City of Richmond Department of Planning and Development Review

Urban Design Committee

Presentation to Planning Commission

UDC Recommendation: Approval with Conditions

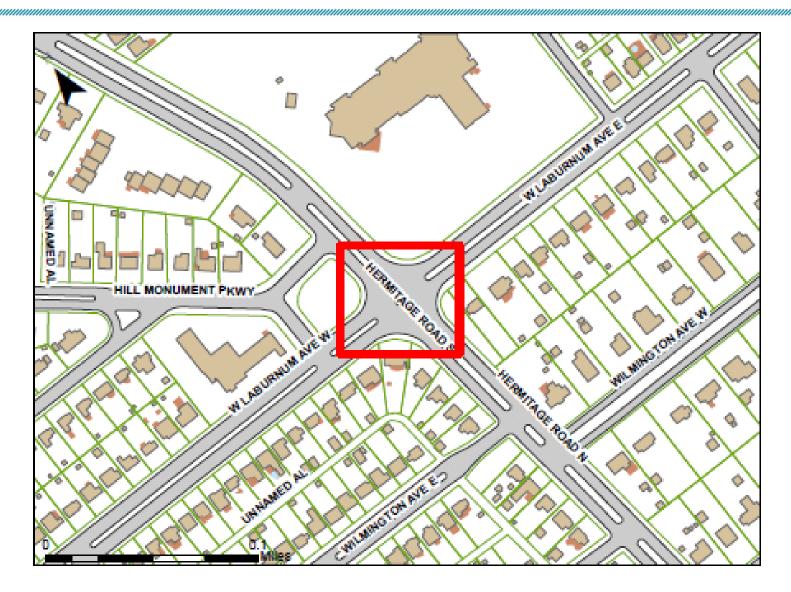
After removal of the monument and related objects, a center, raised island be kept that is circular in form, rather than square

UDC Recommendation: Approval with Conditions

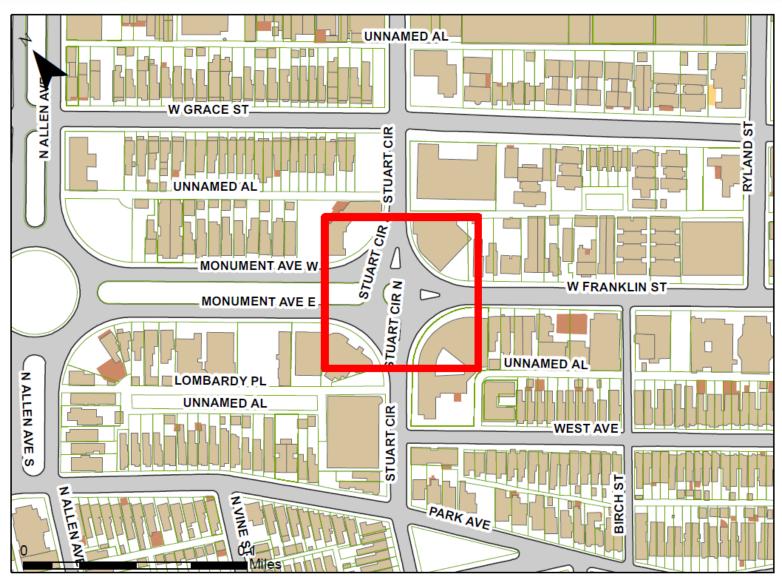
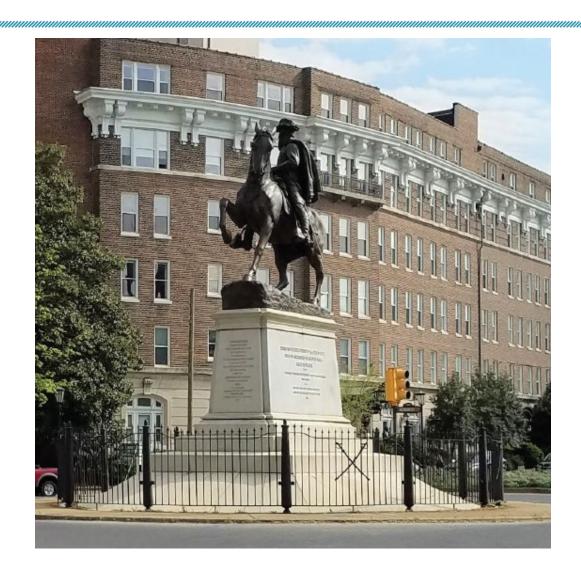
After the monument is removed, the City of Richmond's Department of Public Works prioritize this intersection to receive pedestrian enhancements 3. UDC 2021- 25
499 Stuart Circle
Final location, character, and extent review of the removal of a monument and pedestal; J.E.B. Stuart Monument

UDC Recommendation: Approval with Conditions

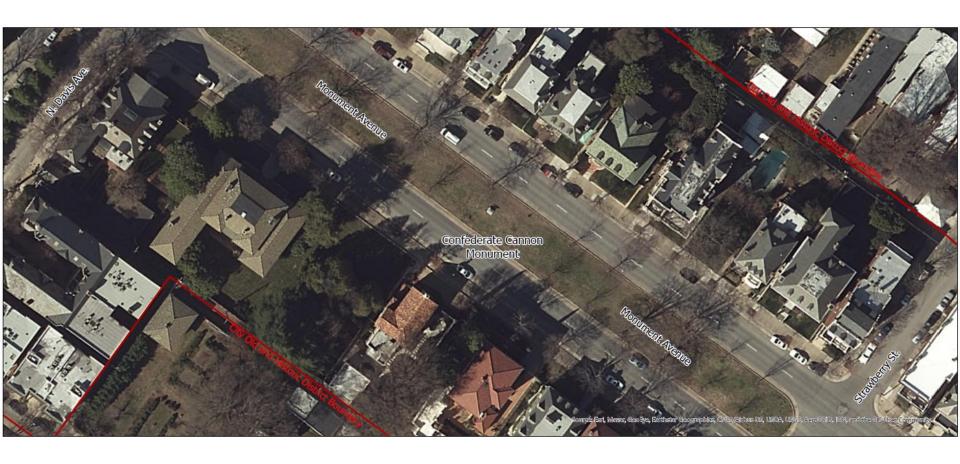
• The landscape plan be updated to be a simplified design of seeded lawn, perimeter plantings, or low maintenance plantings in order to appear more temporary and to allow for public access into the space.

UDC Recommendation: Approval with Conditions

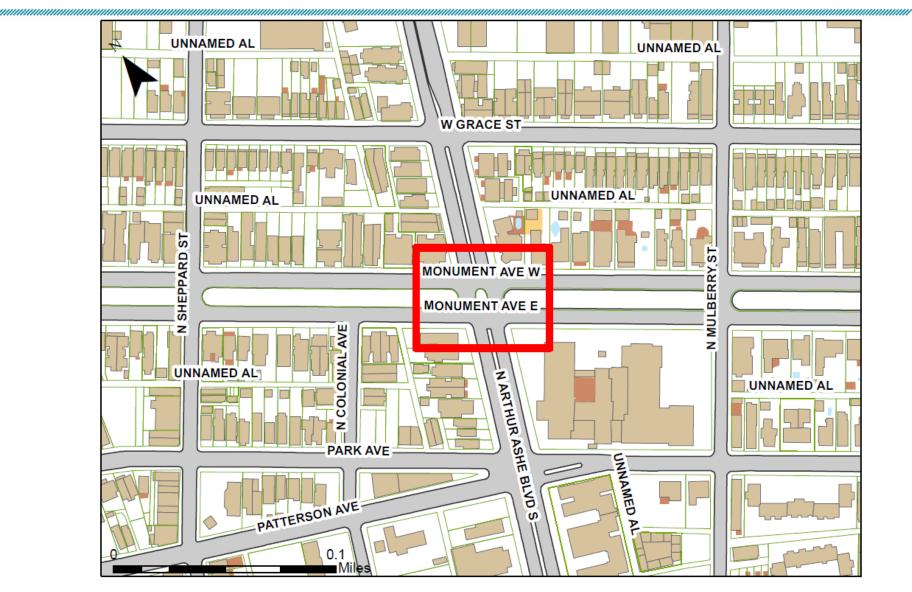
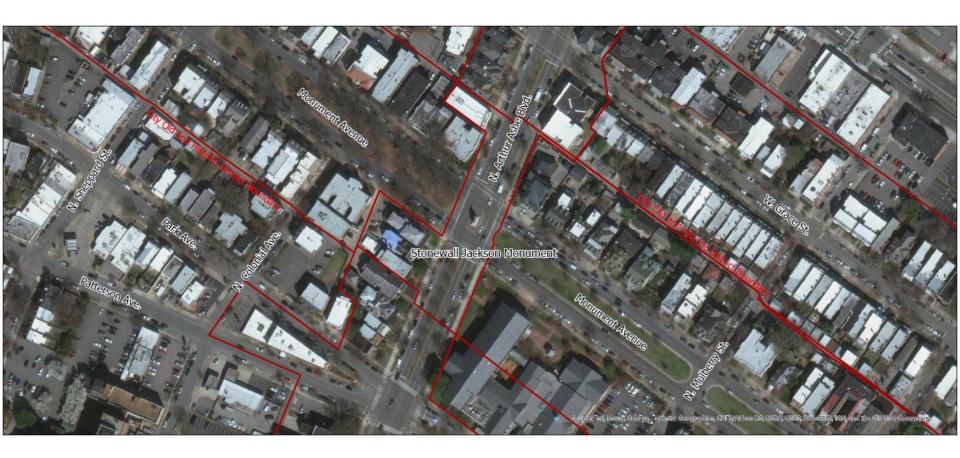
The landscape plan be updated to be a simplified design of seeded lawn, perimeter plantings, or low maintenance plantings in order to appear more temporary and to allow for public access into the space. 6. UDC 2021-28
2799 Monument Avenue
Final location, character, and extent review of the removal of a monument and pedestal; Stonewall Jackson Confederate
Monument

UDC Recommendation: Approval with Conditions

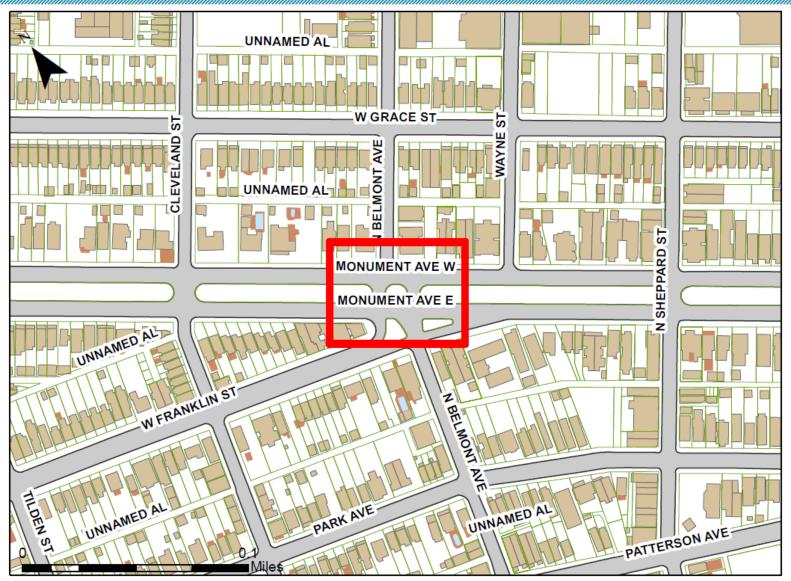
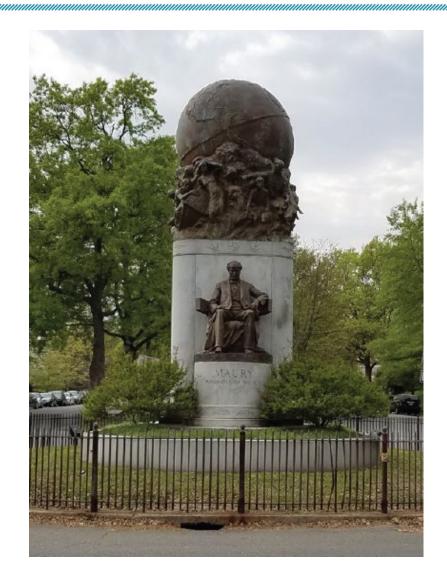
After the monument is removed, the City of Richmond's Department of Public Works prioritize this intersection to receive pedestrian enhancements 7. UDC 2021-29
3099 Monument Avenue
Final location, character, and extent review of the removal of a monument and pedestal; Matthew Fountaine Maury
Confederate Monument

UDC Recommendation: Approval with Conditions

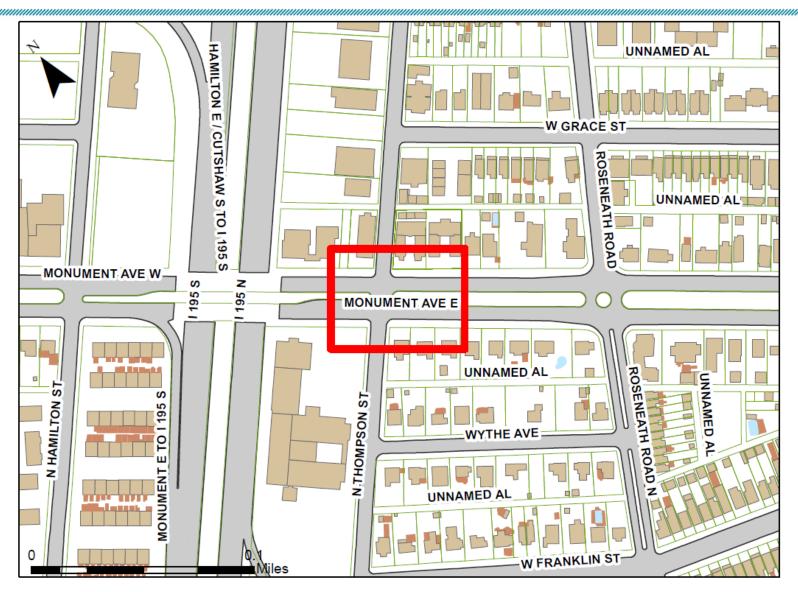
The landscape plan be updated to be a simplified design of seeded lawn, perimeter plantings, or low maintenance plantings in order to appear more temporary and to allow for public access into the space. 8. UDC 2021-30
3499 Monument Avenue
Final location, character, and extent review of the removal of a confederate cannon monument; Confederate Cannon #2
